Rhode Island Airport Corporation

ADDENDUM NO. 1
Invitation for Bids No. 36109
REHABILITATION OF DELIVERY DRIVE PARKING LOT
Rhode Island T. F. Green International Airport

Prospective proposers and all concerned are hereby notified of the following changes in the document(s) related to **IFB 36109**. These changes shall be incorporated in and shall become an integral part of the contract documents.

PROJECT: RHODE ISLAND T. F. GREEN INTERNATIONAL AIRPORT (PVD)
WARWICK, RHODE ISLAND
REHABILITATION OF DELIVERY DRIVE PARKING LOT
TITLE: SITE PAVING DETAILS

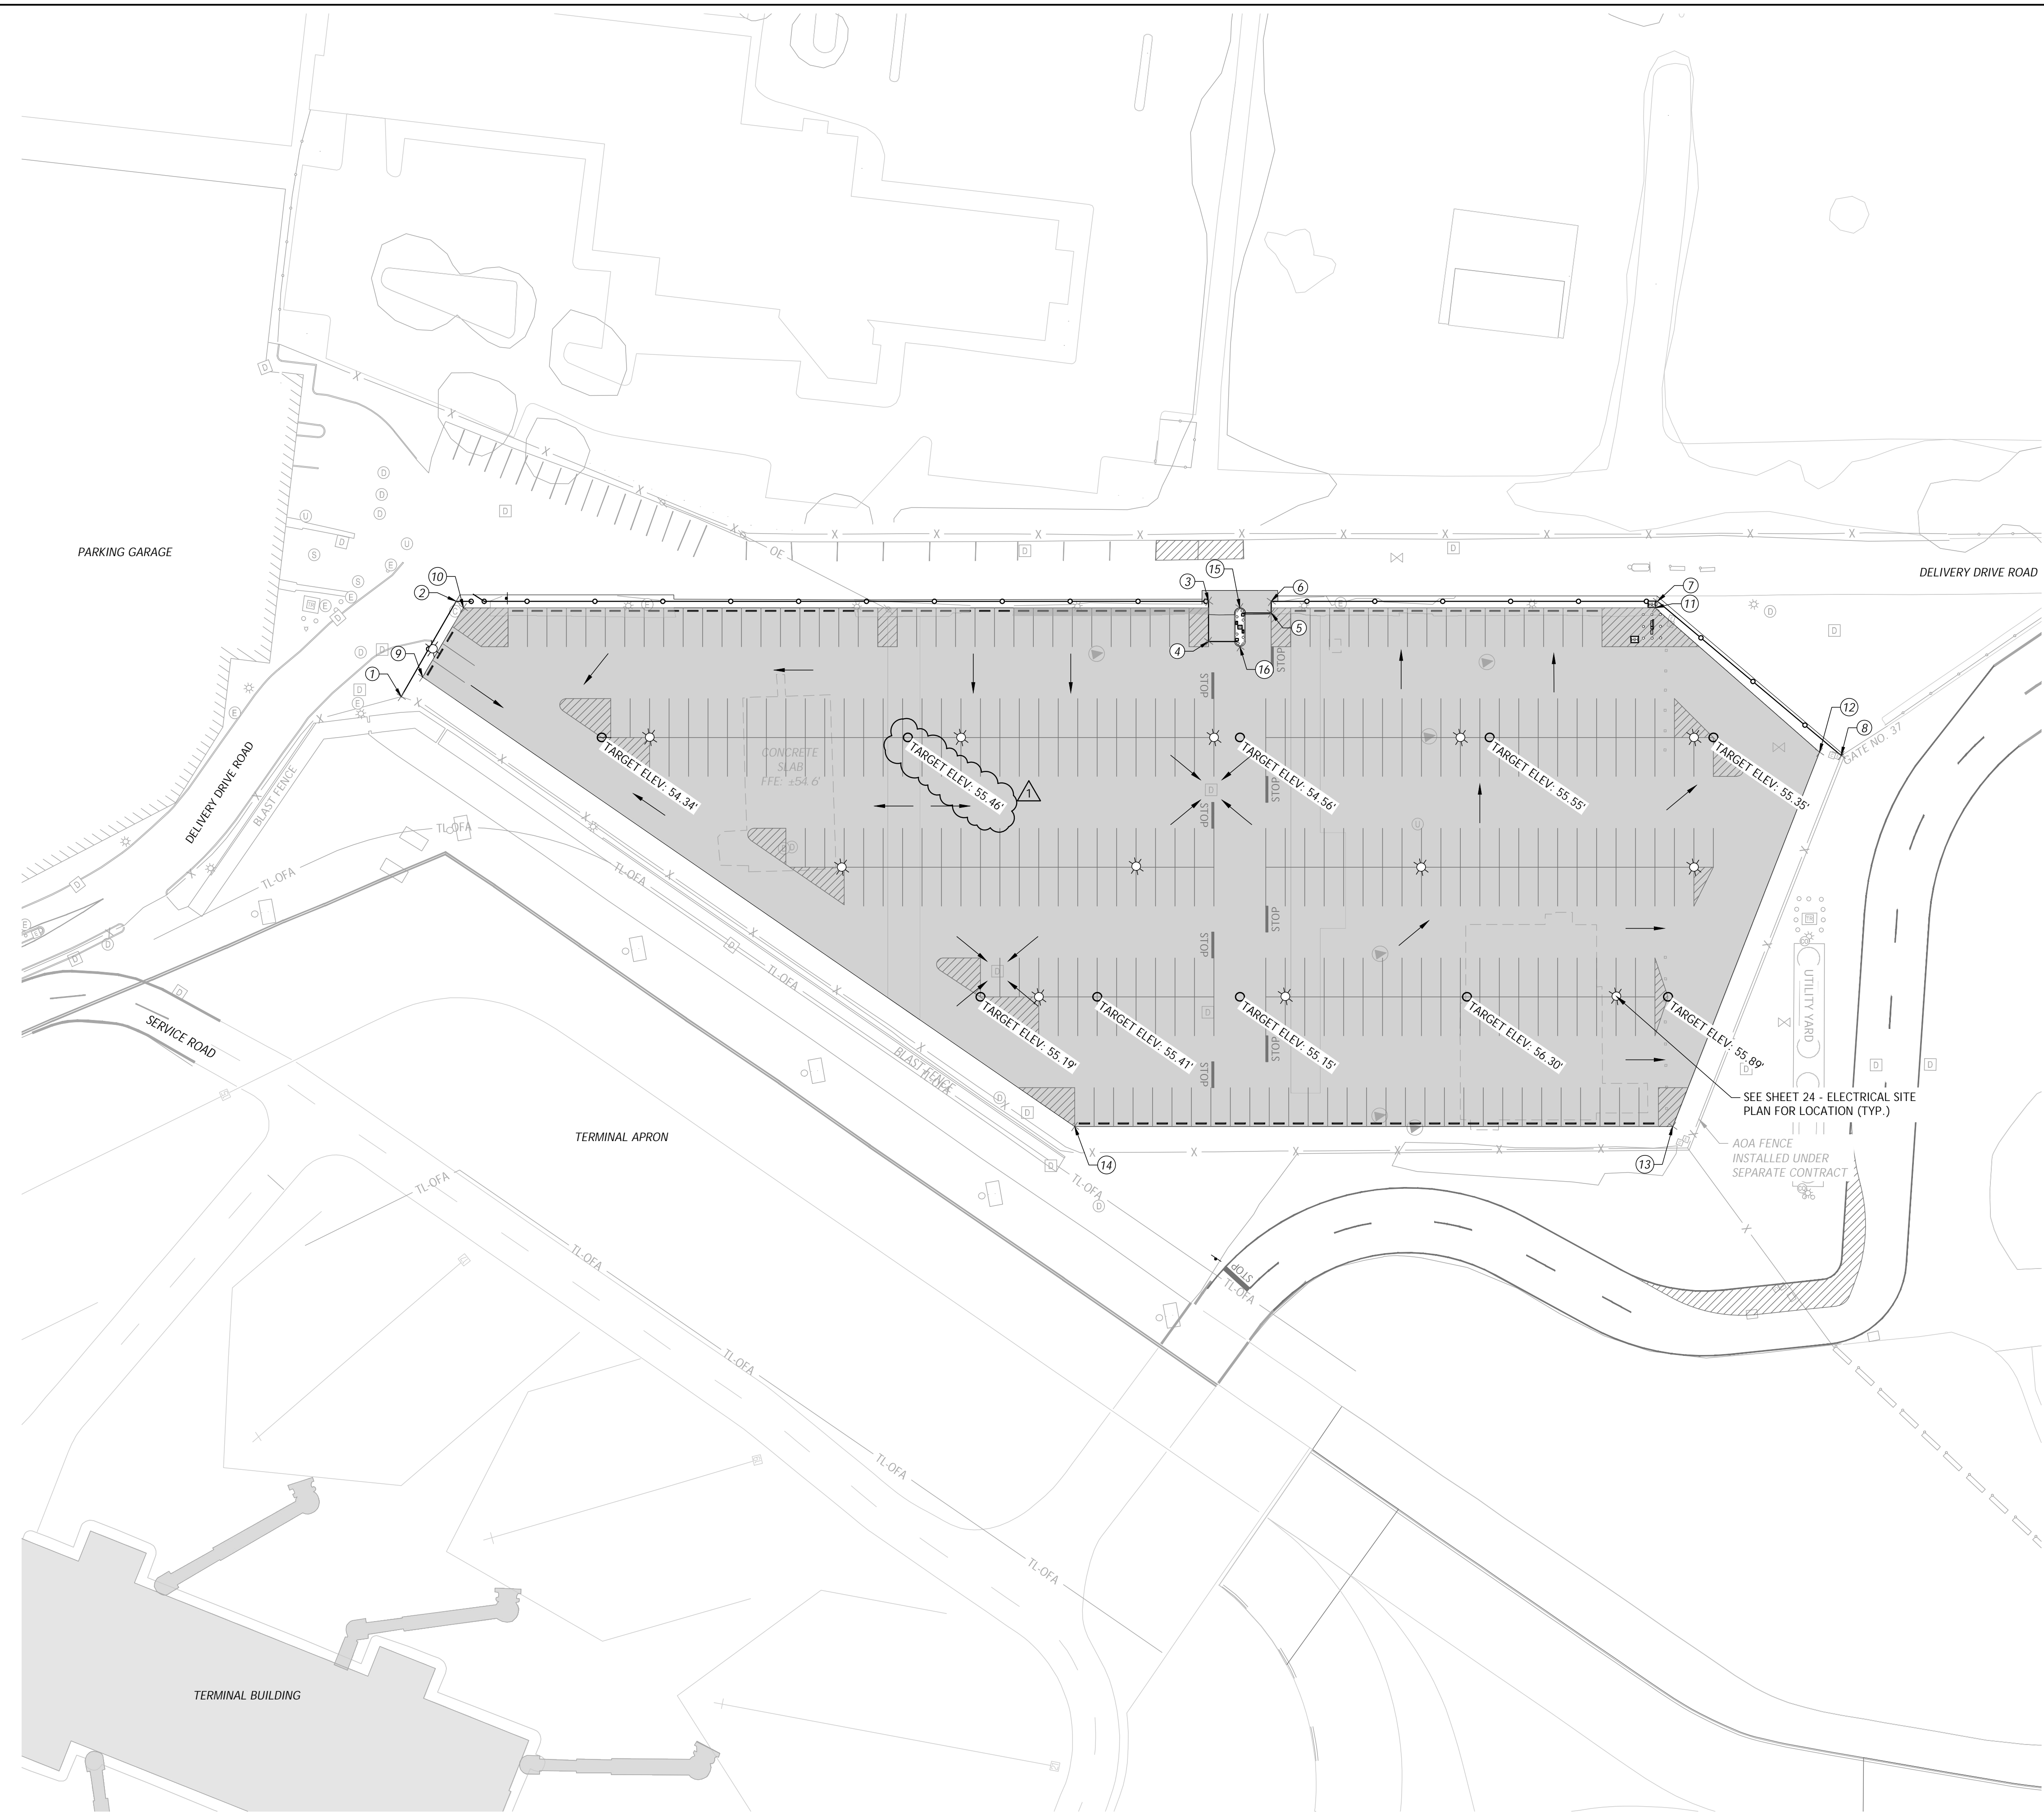
iv. Sheet 14

- Replace sheet 14 in its entirety and replace with sheet 14(R-1) attached to this addendum. Asphalt Overlay Section has been updated.

1. Please clarify that Modified 19.0 is required for item 23. Usually, modified oil is not used in base mix.

Answer: *'Modified' has been retracted from items referring to Class 19.0 HMA pavement with the plan set and specifications.*

TITLE: LAYOUT & SPOT ELEVATION PLAN

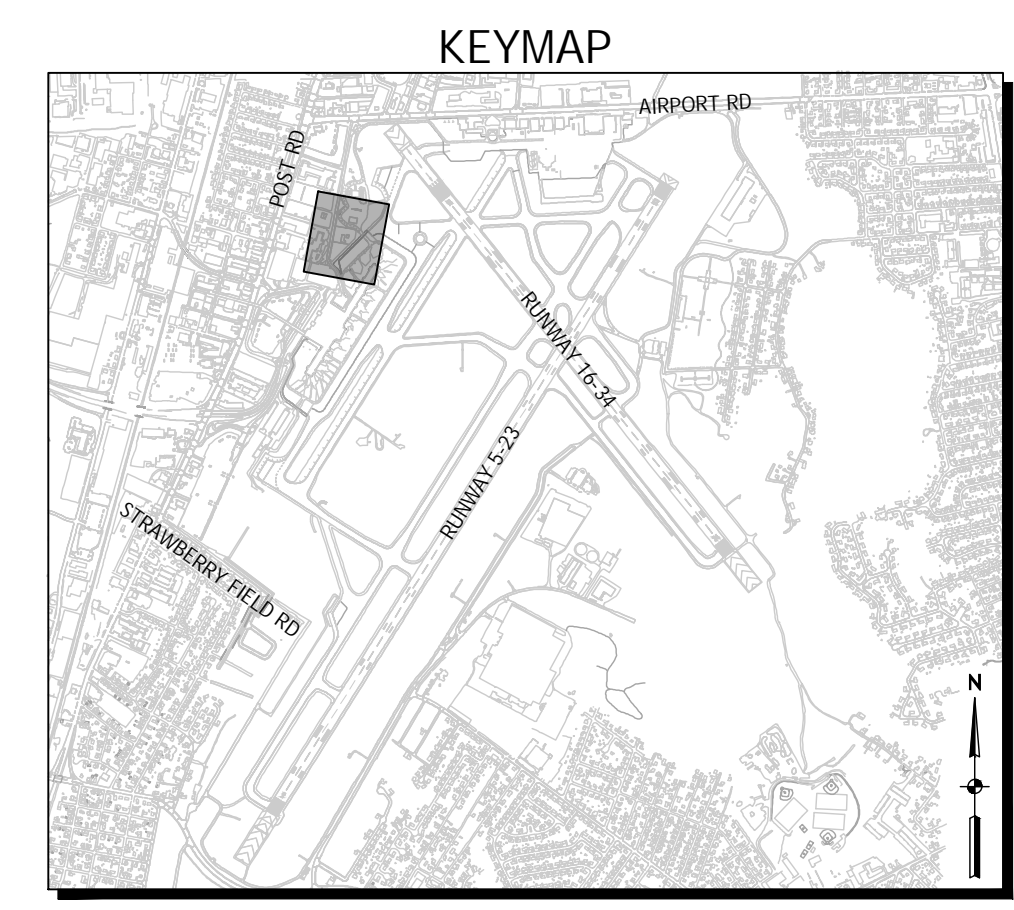
v. Sheet 19

- Replace sheet 19 in its entirety and replace with sheet 19(R-1) attached to this addendum. Plans have been updated.

TITLE: GRADING PLAN

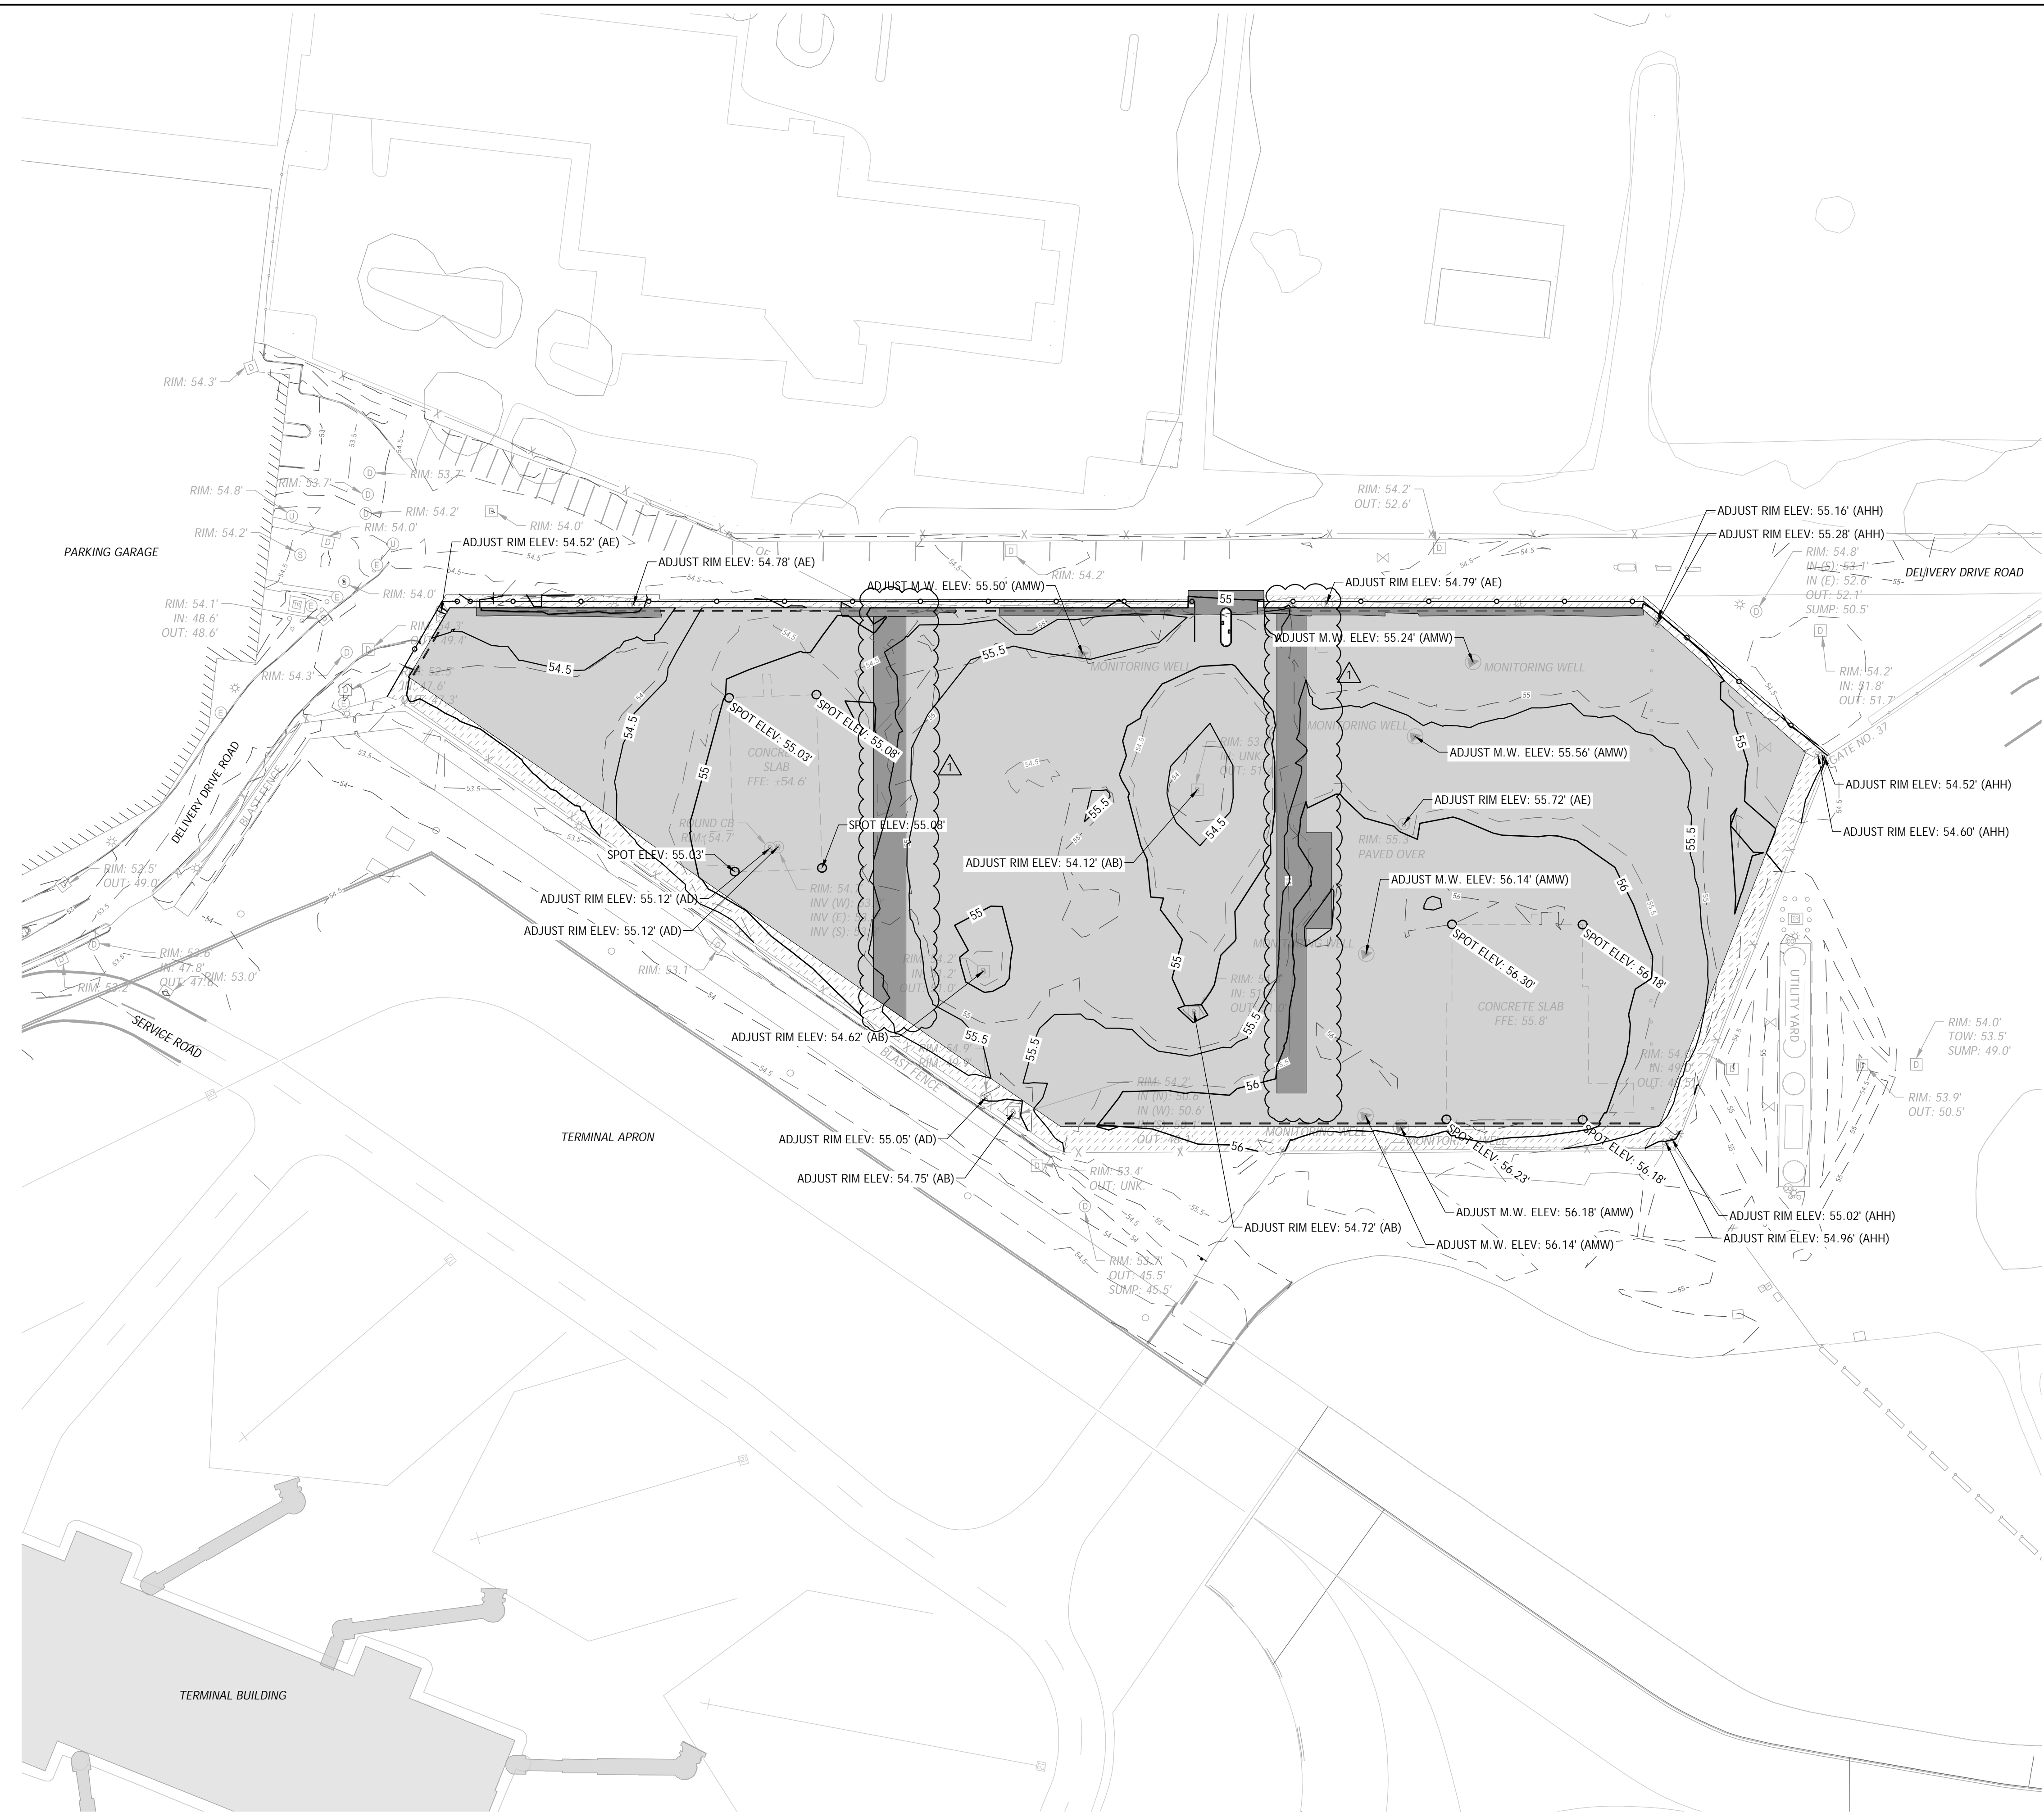
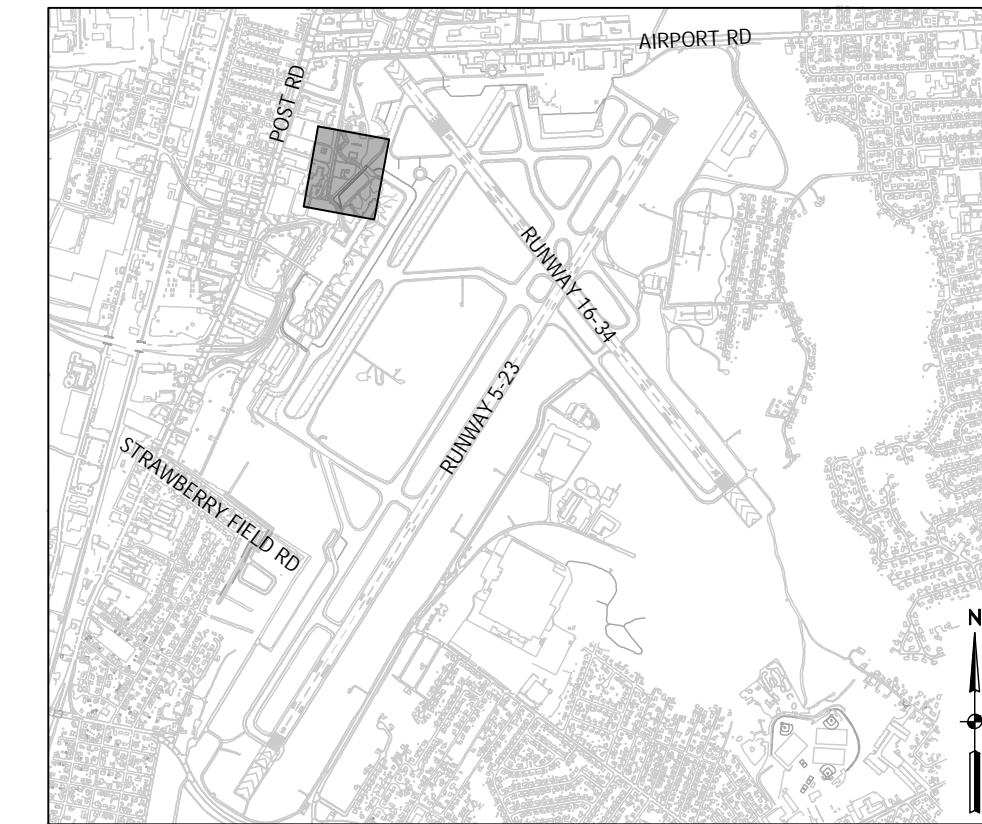
vi. Sheet 20

- Replace sheet 20 in its entirety and replace with sheet 20(R-1) attached to this addendum. Plans have been updated.
